AGENDA
SOUTHERN CORRIDOR REVIEW BOARD
Wednesday, May 8, 2013
3:00 P.M.

STAFF REPORT – SOUTHERN CORRIDOR REVIEW BOARD DEPARTMENT OF GROWTH MANAGEMENT

MEETING DATE:	May 8, 2013
PROJECT:	Parker’s Convenience Store – Certificate of Appropriateness – Highway Corridor Overlay
PROJECT MANAGER:	Erin Schumacher, Senior Planner

EXTERIOR ELEVATIONS

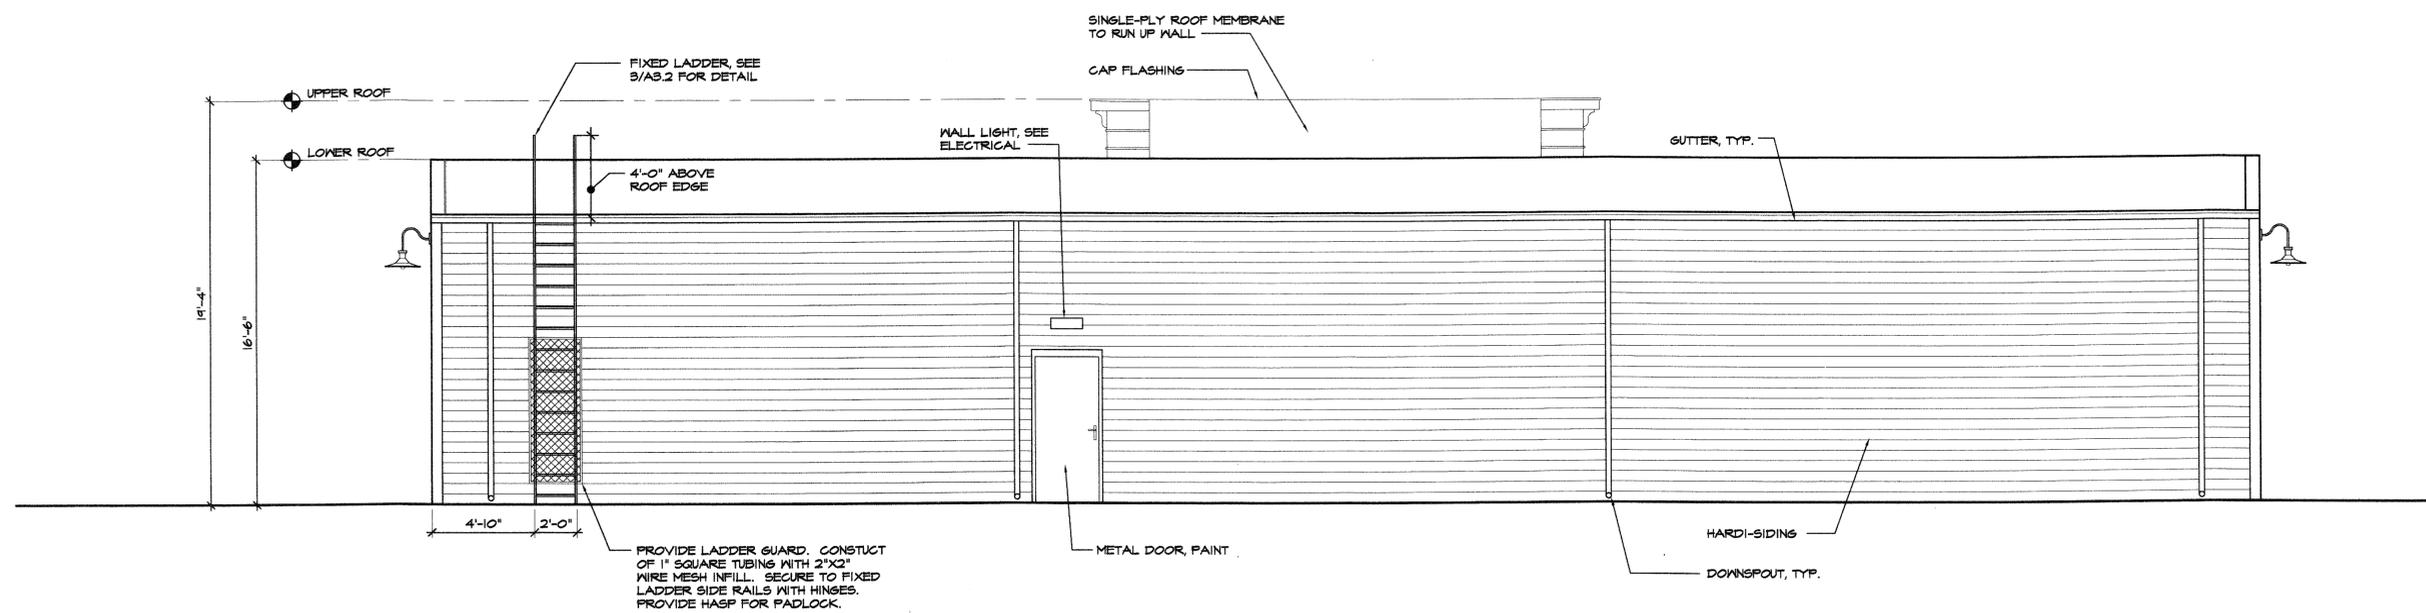
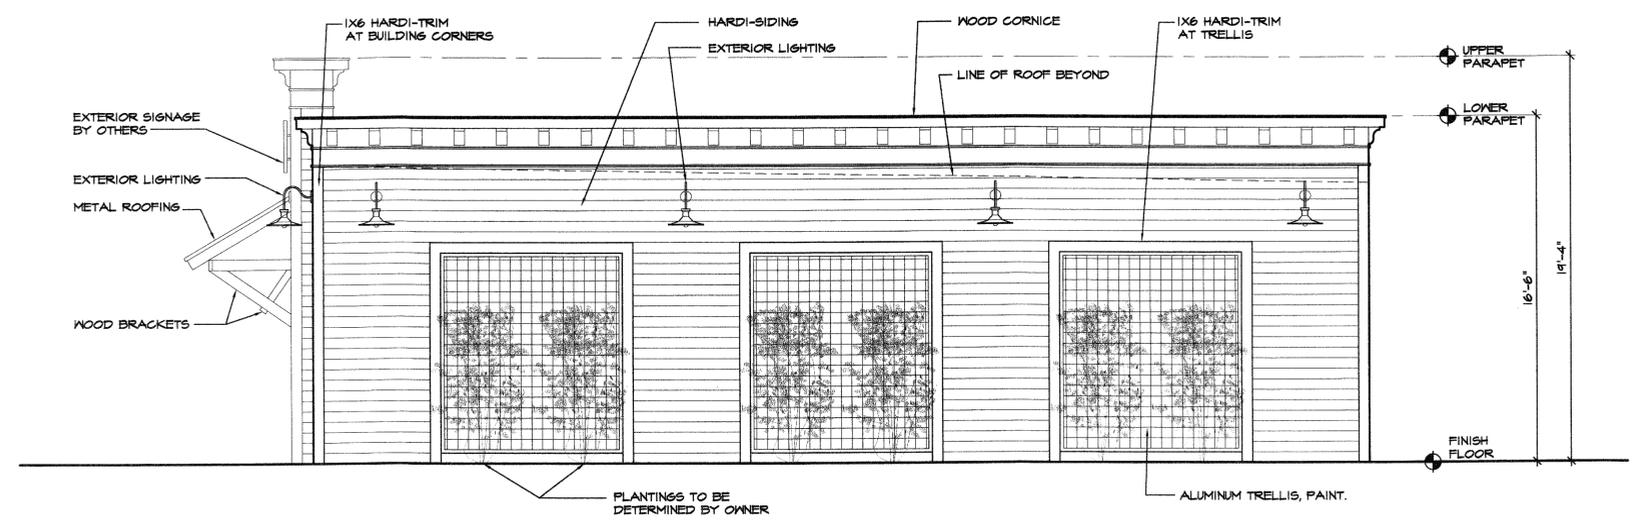
- B. Section 5.14.3.B.2. Sides of Buildings and Structures. Long, unarticulated, blank facades are not permitted. While the Applicant has provided architectural hierarchy in the front façade and made an attempt to articulate sides of the building by incorporating vegetative panels, the current design of the rear of the building, which faces Jennifer Court, does not meet this requirement. It is a long unarticulated façade where no attempt was made to step the building, differentiate the building materials, or add architectural features to articulate the facade. The rear façade, while being a service entrance will face whatever future development arises on the developable properties to the north. This façade must be redesigned with appropriate architectural detailing to break up the façade visually and/or physically to meet the intent of the review criteria and create an architecturally interesting elevation facing Jennifer Court.

In addition, and as noted previously, the front façade would be improved and more in keeping with the vernacular of the May River Scenic Byway and Bluffton Historic District, by adding additional bracketed roof structures above the aluminum storefront systems to further articulate the front façade with features common to the Lowcountry. As well, bracketed roof structures over the entry doors located at the side and rear, similar to

that proposed at the front entry, would add further articulation on the side and rear entrance of the structure. Finally, the use of a vertical siding material, such as board and batten, which creates vertical shadow lines providing a more dimensional material configuration, would help break up the long horizontal spans of the building exterior.

- iv. Per Section 5.14.3.B.2.1, the long, unarticulated, blank façade of the rear and side elevations shall be articulated visually by changing the building materials and colors and/or physically by stepping the exterior of the building envelope or adding architectural features that provide visual depth such as bracketed roofs with knee braces over the aluminum store front glass systems and above the other points of egress on the building.

GAS CANOPY ELEVATIONS

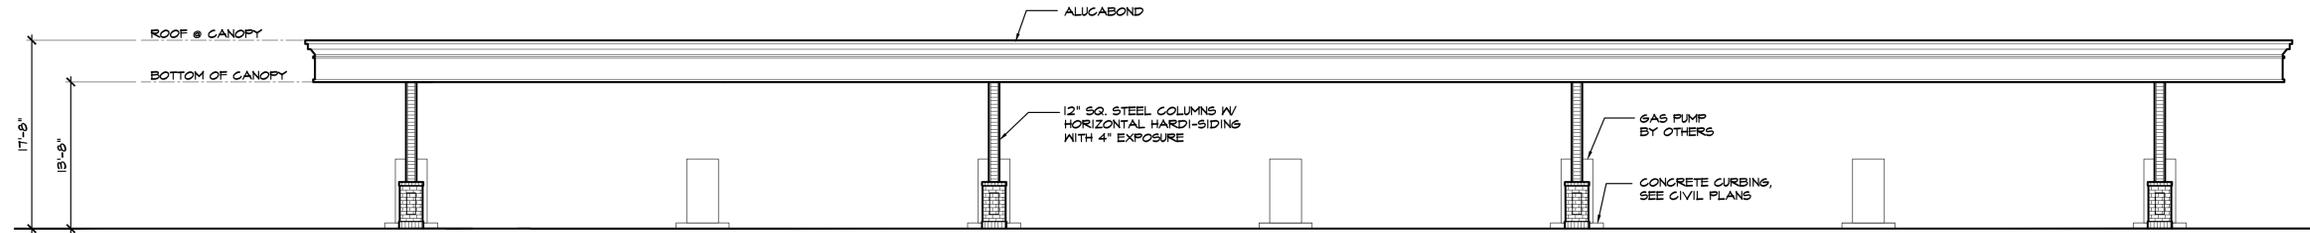
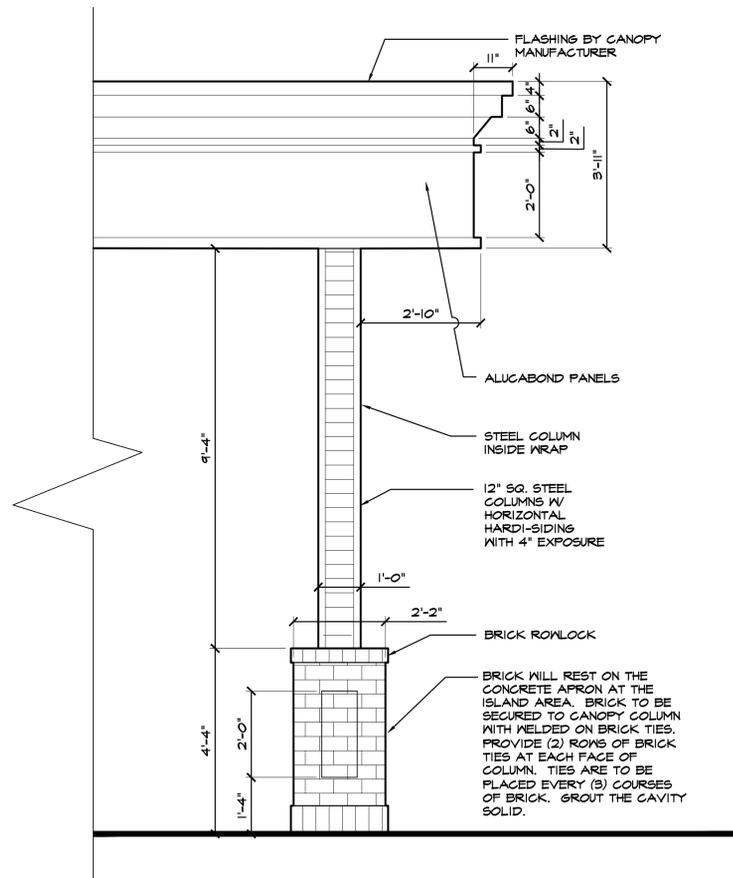
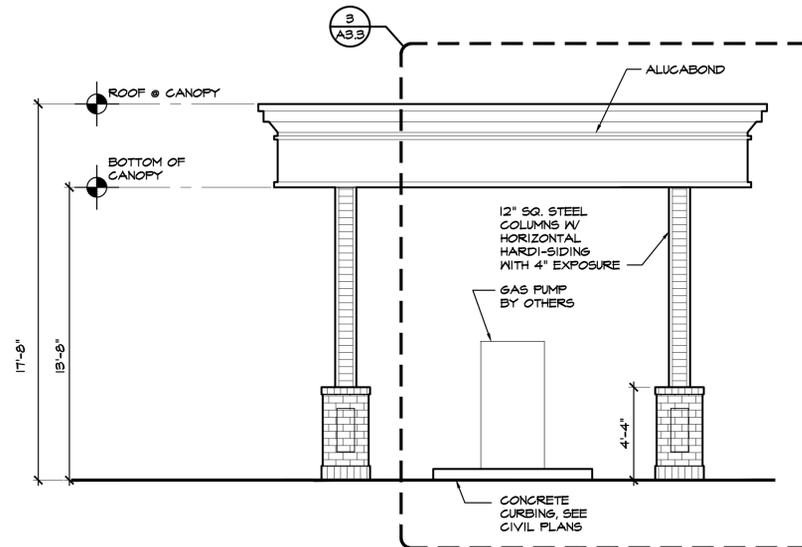
- A. Section 5.14.3.B.1. Roofs. The UDO states that roof overhangs and pitched roofs shall be incorporated into all building designs. It also states that roofs with very low pitches and flat roofs are permitted provide there is a pediment. The configuration of the main building's roof is permitted because it each meets this requirement. On the other hand, the UDO prohibits long, unarticulated roofs. The canopy, spanning over 180 linear feet, with no undulation or articulation does not meet this standard. To more appropriately address this requirement, the canopy roof structure must be modified to incorporate pitched roofs and/or broken up into modules that are visually cohesive but differentiated from one another. This will also help to minimize the overall mass of the canopy and permit greater visibility of the structure behind. Additionally, since the building features a flat roof with a pediment, additional bracketed roof structures must be added along the aluminum store fronts and at the points of egress. This will incorporate roof overhangs and pitched roofs into the design and provide vernacular features meeting the design intent of this and other Sections of the UDO.

- D. Section 5.14.3.B.4. Accessory Uses. The UDO states that the design of accessory buildings or structures shall reflect and coordinate with the general style of architecture inherent in the primary structure for the proposed development. As proposed, there is a visual disconnect between the style of architecture of the primary structure, that of the canopy structure, and that of the dumpster enclosure. The building takes on characteristics of other commercial structures found in the greater Bluffton area by incorporating a pediment surround to hide the flat roof behind, adding an entablature with decorative bracketing along the cornice, using typical materials like hardiplank siding and metal roofing, and incorporating a shed roof supported with wooden triangle knee braces at the entry. Meanwhile the canopy has a more refined appearance, using decorative brick plinths with hardiplank wrapped steel columns holding up a monolithic canopy that features an unsuitably thick entablature of aluminum composite panels. The only feature of the canopy that relates to the building is the application of hardiplank to the steel columns which is inappropriate from an architectural and constructability standpoint. Moreover, the entablature proportions between the two are visually unbalanced. The entablature of the building consists of a bracketed cornice over a frieze of the same width as the brackets. Conversely, the entablature of the canopy has a contoured cornice over a frieze that is nearly two and a half times the width of the cornice creating a visual disconnect which is only further magnified due to the length of the canopy. In the composite elevation, the

canopy entablature appears thick enough to completely cover the signage on the building face.

As the locale of Bluffton began as a collection of summer homes for nearby plantation owners which later evolved into a center of commerce for the area by way of water, the structures were simple and made of easily available materials such as wood siding, tabby, and metal or shake for roofing materials. Few instances of period brick structures exist and even fewer examples of high style architecture exist. Therefore, not only are the materials of the canopy inappropriate for this area of this location in such close proximity to the Bluffton Historic District, but so is the monolithic and grand proportions of the canopy profile. Therefore, the canopy should be redesigned to incorporate pitched roofs and broken into modules. If an entablature is used, the frieze should be narrowed to result in an entablature that is more in keeping with the dimensions of the entablature of the building. This would provide a better relationship between the two structures. Additionally, an alternative material, one that is simple and straightforward, such as post and beam construction, should be used for the posts or the post cladding and the plinths should be of an archetypal material such as tabby rather than brick.

- ii. Per Section 5.14.3.B.1, the roof structure of the canopy shall be revised to incorporate pitched roofs.
 - iii. Per Section 5.14.3.B.1.3, the long unarticulated roof of the canopy shall be broken down into several architectural modules that are visually cohesive but that differentiate the roof configuration along the span.

DUMPSTER ENCLOSURE PLAN

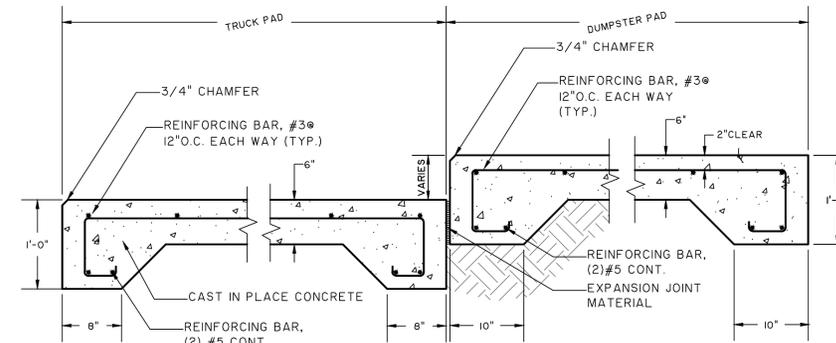
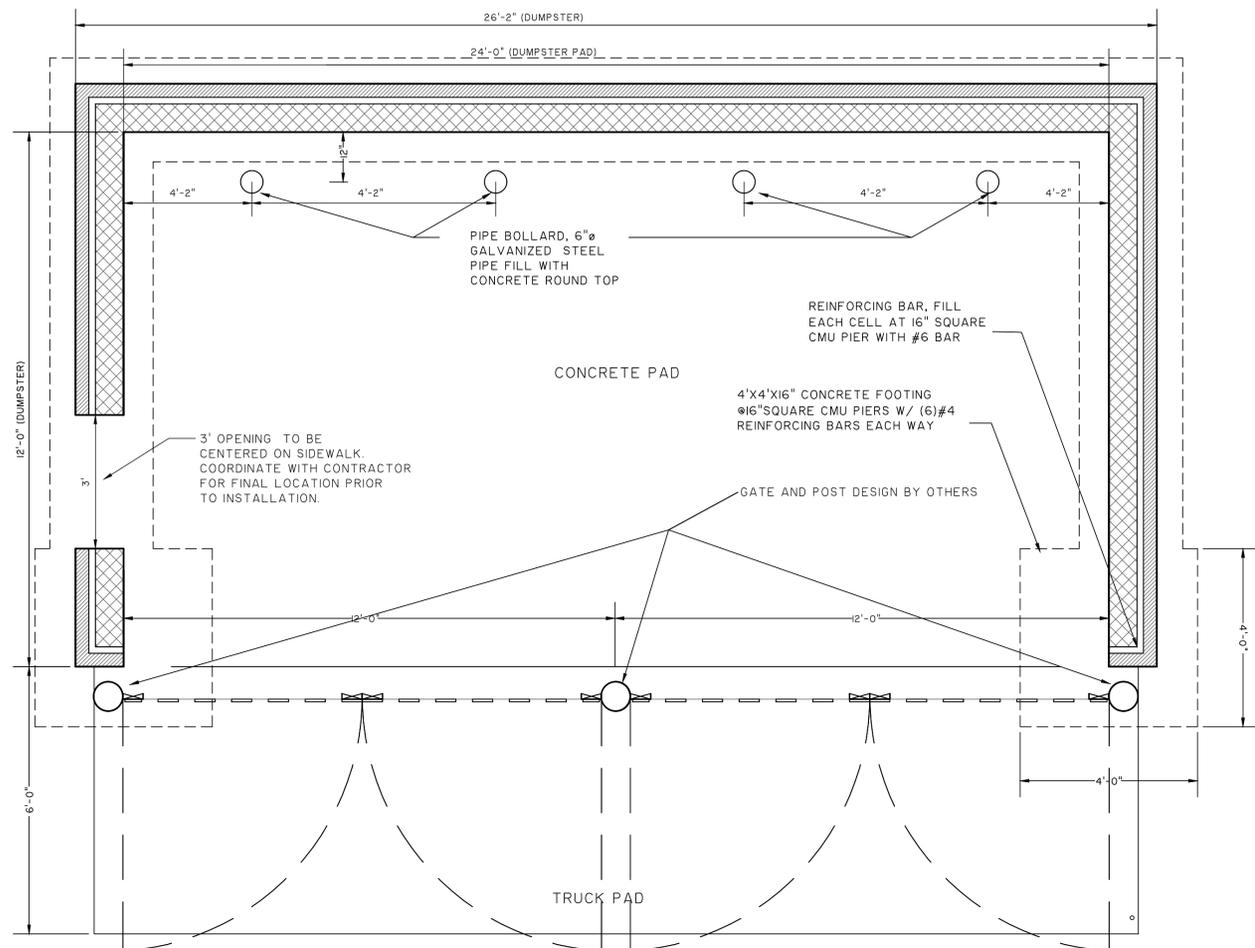
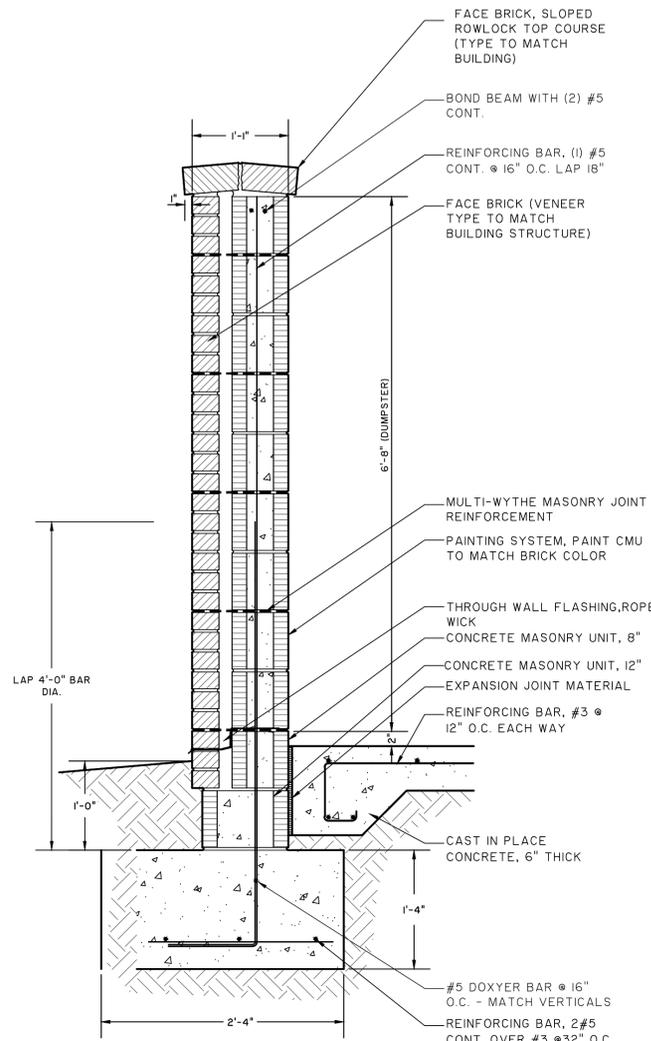
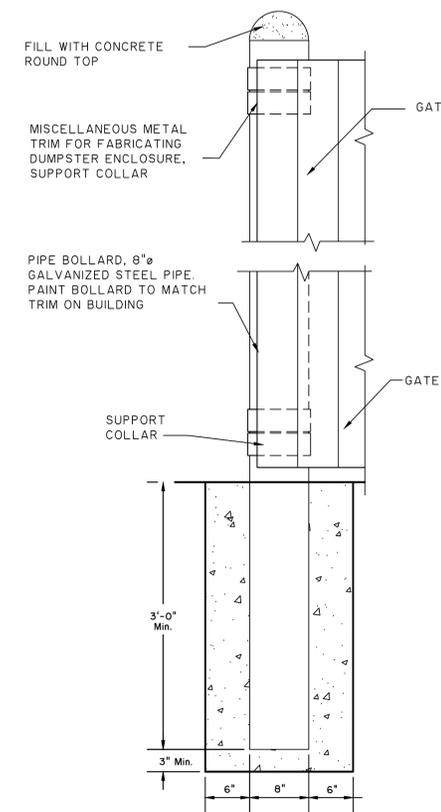
As all the structures should coordinate, and as changes are made to the canopy, the dumpster enclosure should be modified accordingly. For example, if the brick on the canopy plinths is exchanged for tabby stucco, the dumpster enclosure material should likewise be replaced.

- i. Per Sections 5.14.3.A.2 and 5.14.3.B.4, as the project includes multiple built structures, their building materials, architectural forms, scale, color, and textures shall be revised to be consistent and/or stylistically compatible with the primary building.
